- Subject** ▶ Change in Housing for repair
- For Models** ▶ 6702D, 6702DW, 6703D
- Description** ▶ To standardize with New Models, 6704D, 6705D, and 6706D.

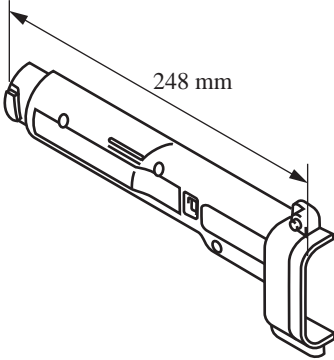
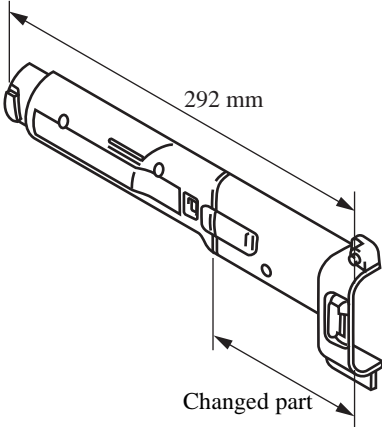
CURRENT	NEW
Housing R/L		
Lead wire #18 (red) (for connecting Battery Holder ⊕ Terminal)	50mm	90mm
Lead wire #18 (black) (for connecting Battery Holder ⊖ Terminal)	50mm	70mm

Item No.	Curret part		Q'ty	I/C	New part		Q'ty	Note
6702DW: 001, 048 6703D: 042, 054	Housing Set 182884-9		1	No	Housing Set 183057-7		1
